DEPARTMENT OF NATURAL RESOURCES

SUBJECT: Surface Use Lease and Mining and Reclamation Plan for the Eagle Project

Eagle Project

**FIGURE 1
SITE DEVELOPMENT PLAN
AND TOPOGRAPHIC MAP**

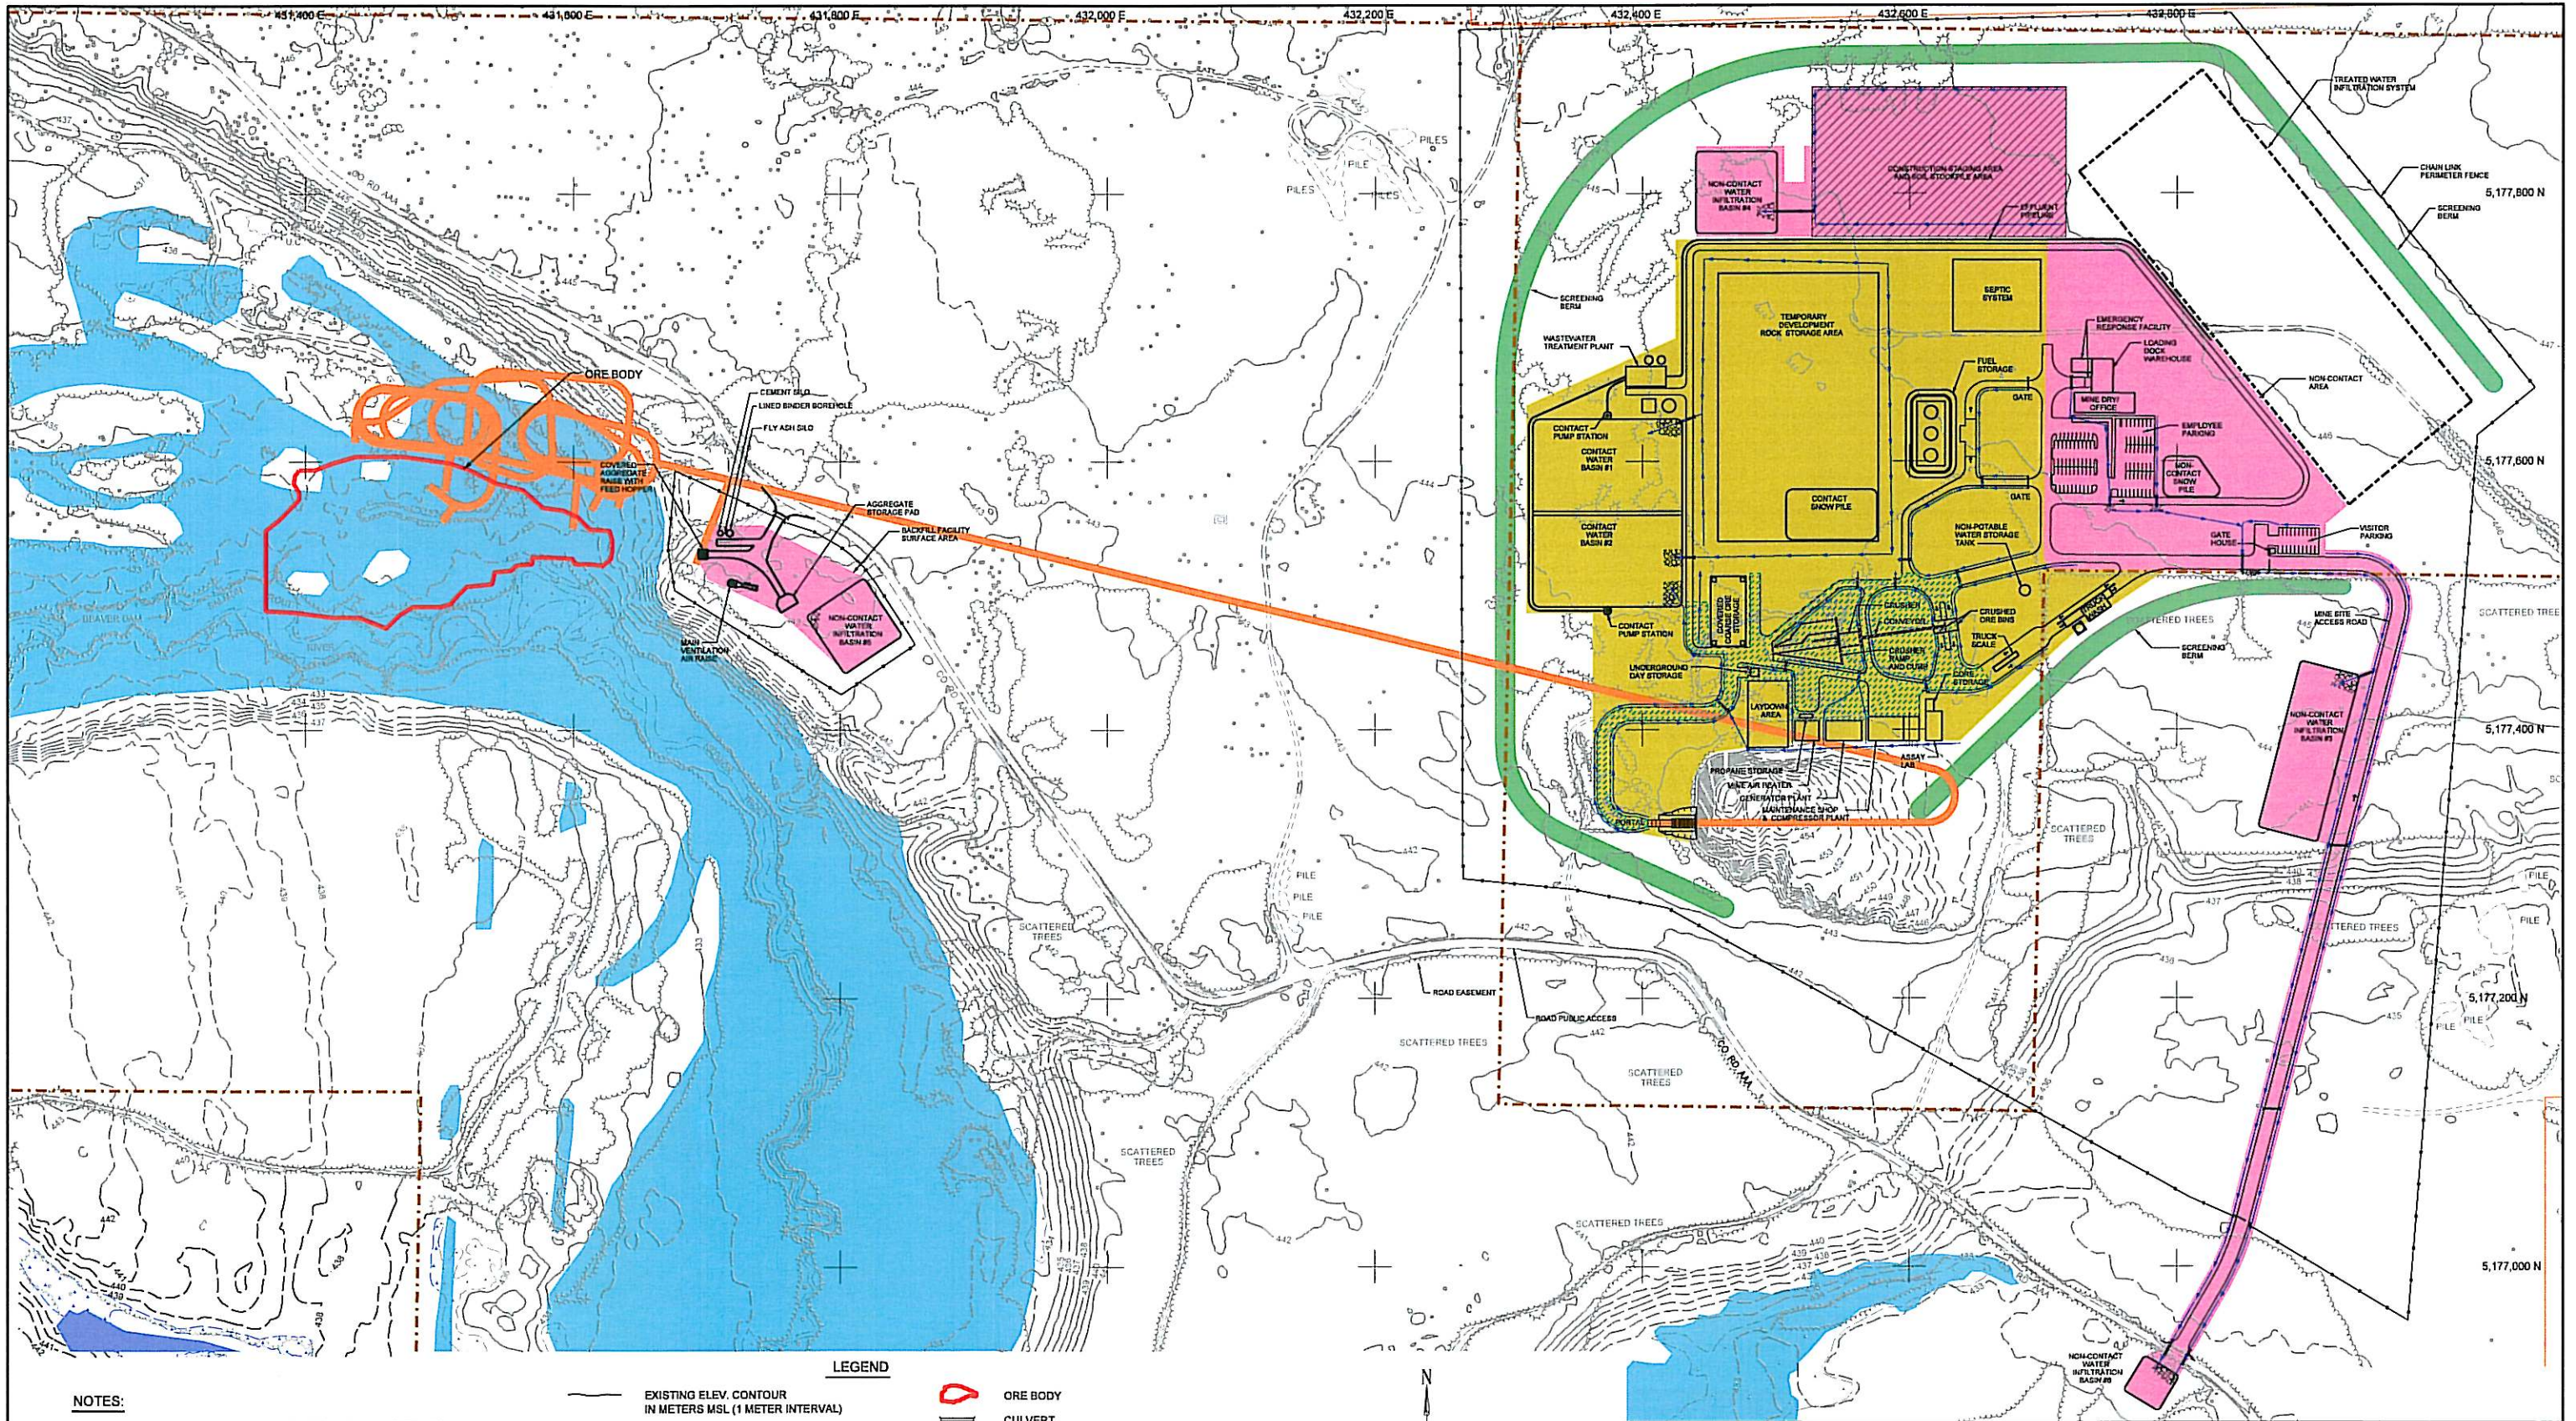
Kennecott provided the Topsoil Management Plan regarding removal, storage, and monitoring of topsoil from excavated areas. The DNR staff believes it will be difficult to obtain restoration of topsoil over a large area commensurate with the pre-mining thickness.

Surface Use Lease Exhibit C has been modified to require additional topsoil of similar character to be brought in from an outside source if Kennecott is unable to restore topsoil on the Premises to a thickness present at pre-mining conditions. The DNR also modifies the Mining and Reclamation Plan to incorporate the topsoil handling practices and procedures identified in the Topsoil Management Plan.

FIGURE 1
PROJECT SURFACE OWNERSHIP AND LOCATION ALTERNATIVES

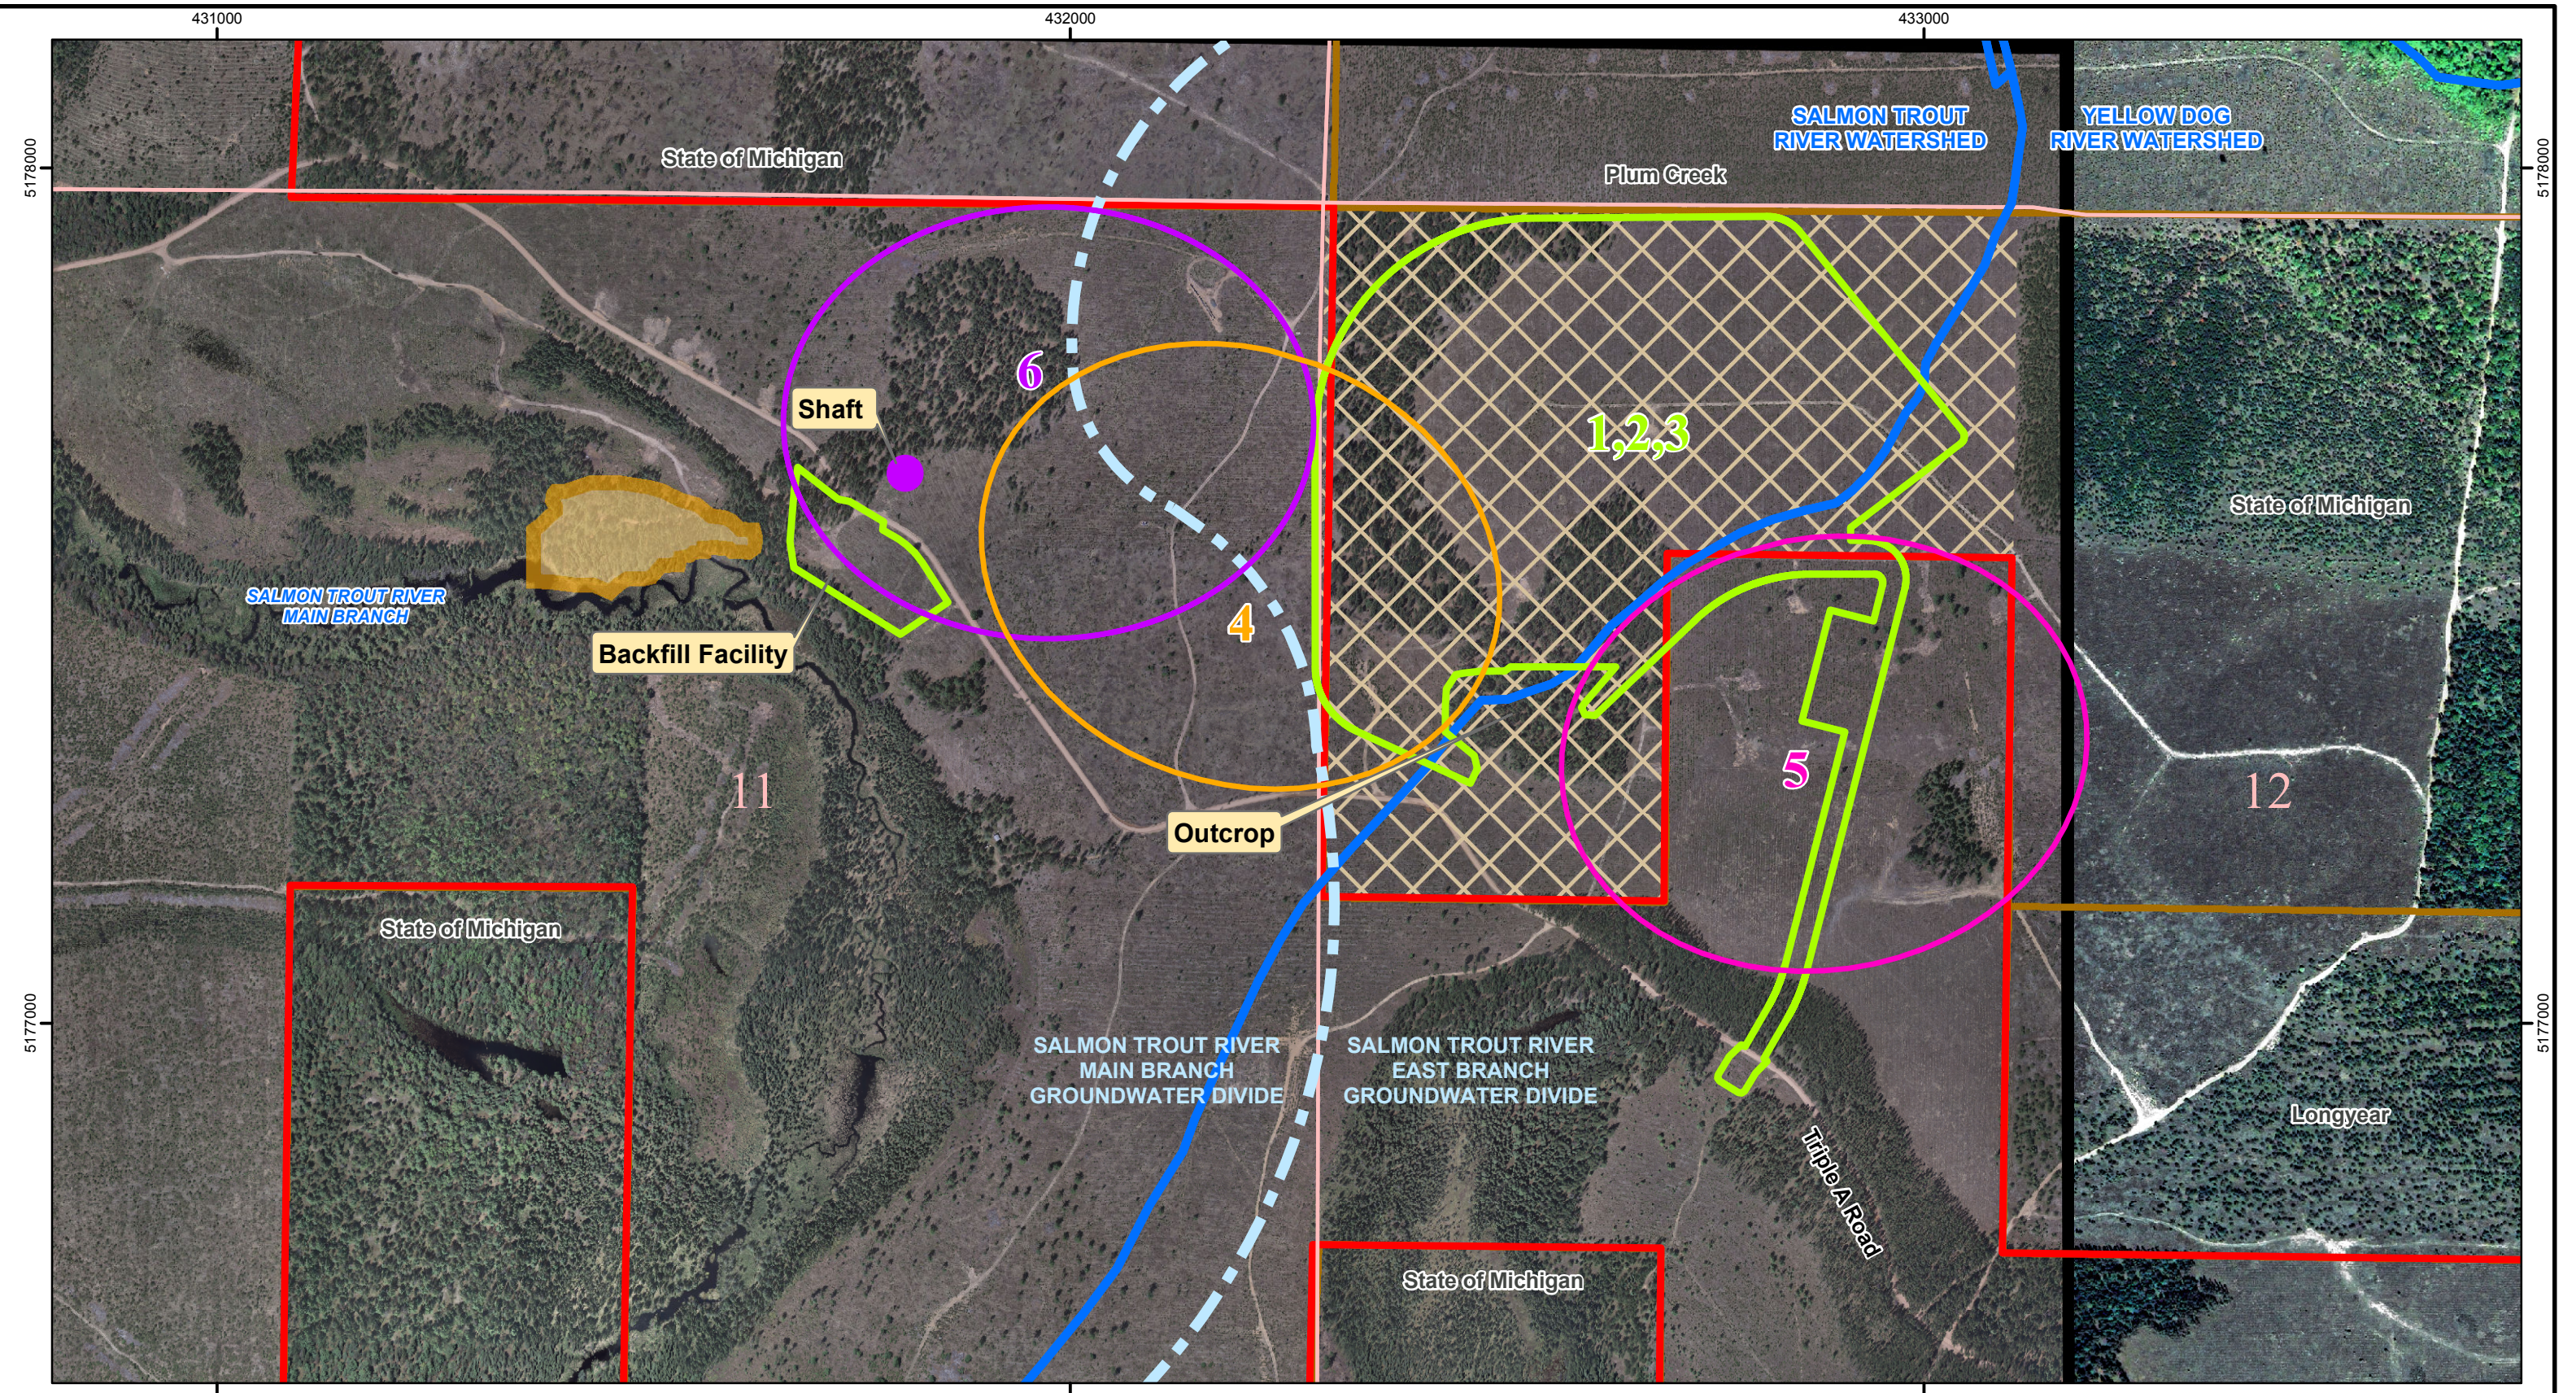
Kennecott provided further analysis of the alternate locations (Kennecott Analysis of Surface Location A-D) it considered for the portal and surface facility. The DNR concurs that the proposed location for the portal and surface facility is a preferred location. Since approximately one-half of the ore body lies on state-owned minerals, the State of Michigan has an interest in having its minerals developed from a preferred location.

FIGURE 1
SUBSIDENCE MONITORING PLAN

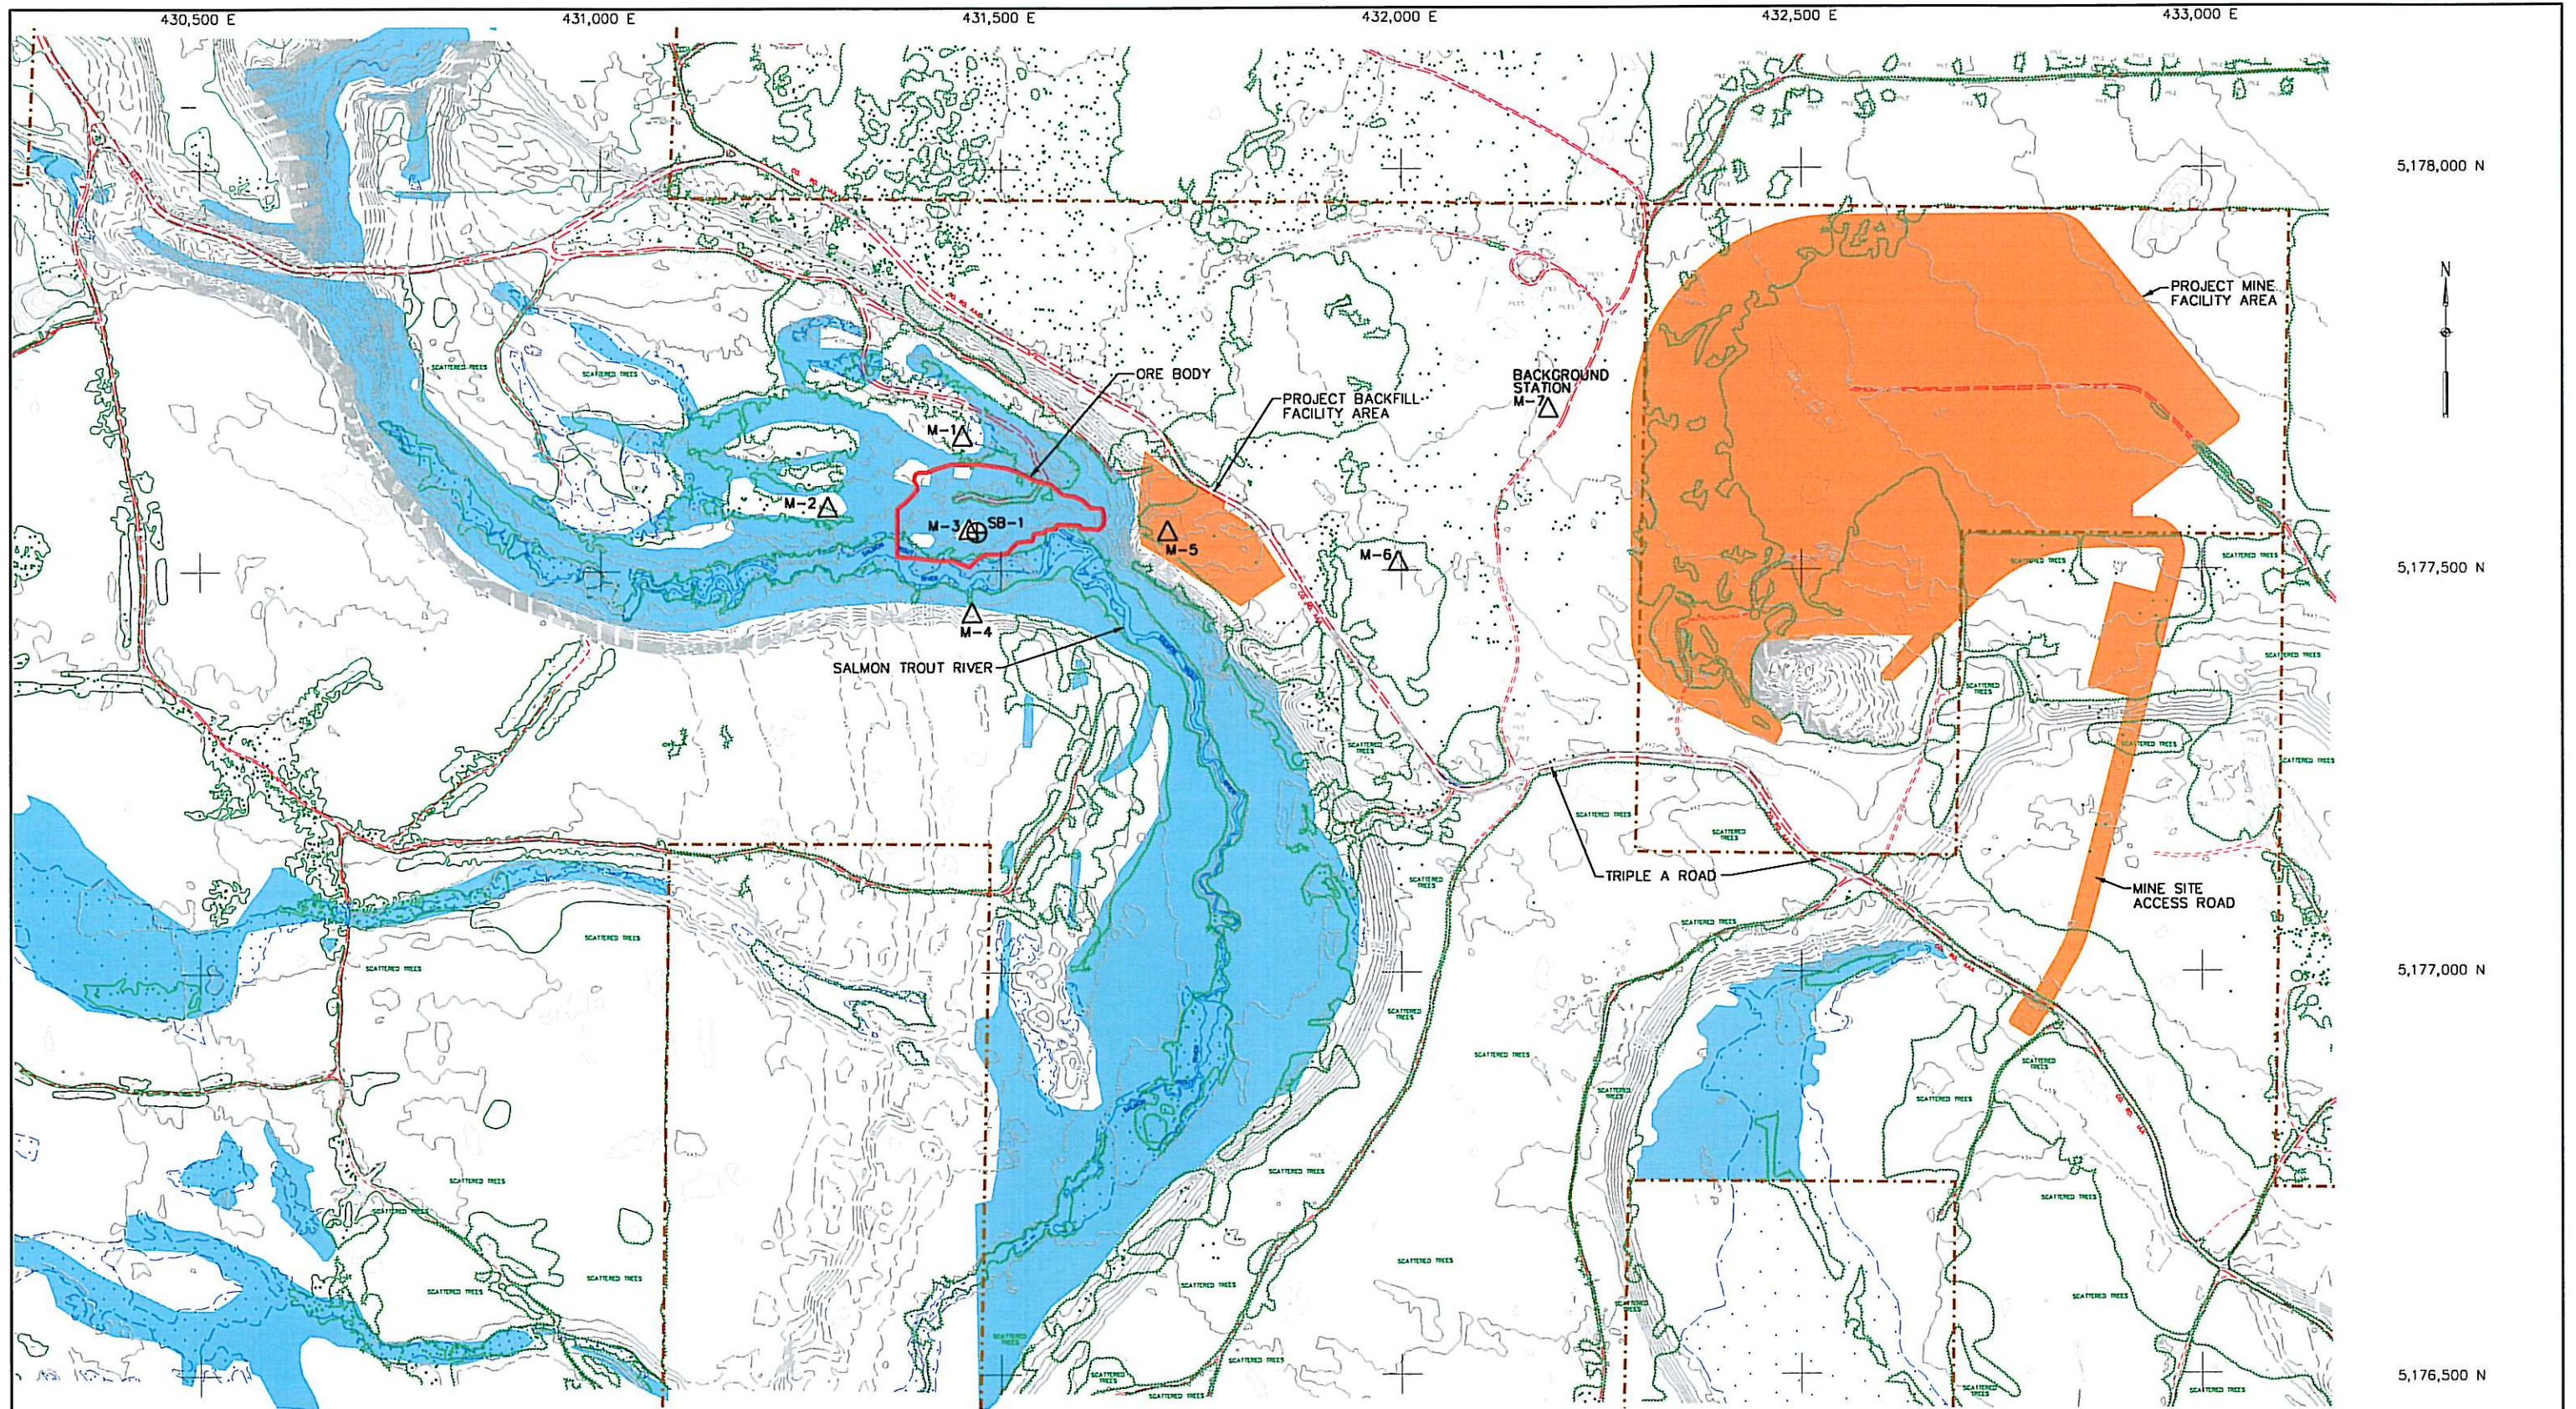
Kennecott provided the enclosed Subsidence Monitoring Station Map depicting the monumented sites to be used for surface and subsurface monitoring. One surface and one subsurface monitoring site will be placed directly over the ore body. Kennecott proposed monthly monitoring which exceeds the quarterly monitoring requirement contained in the DEQ Mining Permit. The DNR was concerned that the one-half inch monthly, and two-inch cumulative standards proposed to determine that subsidence occurred might not be fully protective of the resources. The standard of deflection allowed under the DEQ Mining Permit is essentially zero movement (not counting possible movement due to gravitational effects) at a one-centimeter level of accuracy.

The DNR modifies the Mining and Reclamation Plan to reflect Kennecott's frequency of monthly monitoring, at the array of monitoring sites identified in the attached map. Any net displacement of one centimeter or more from pre-mining conditions will be considered subsidence and will cause corrective action under the DEQ Mining Permit condition E8.
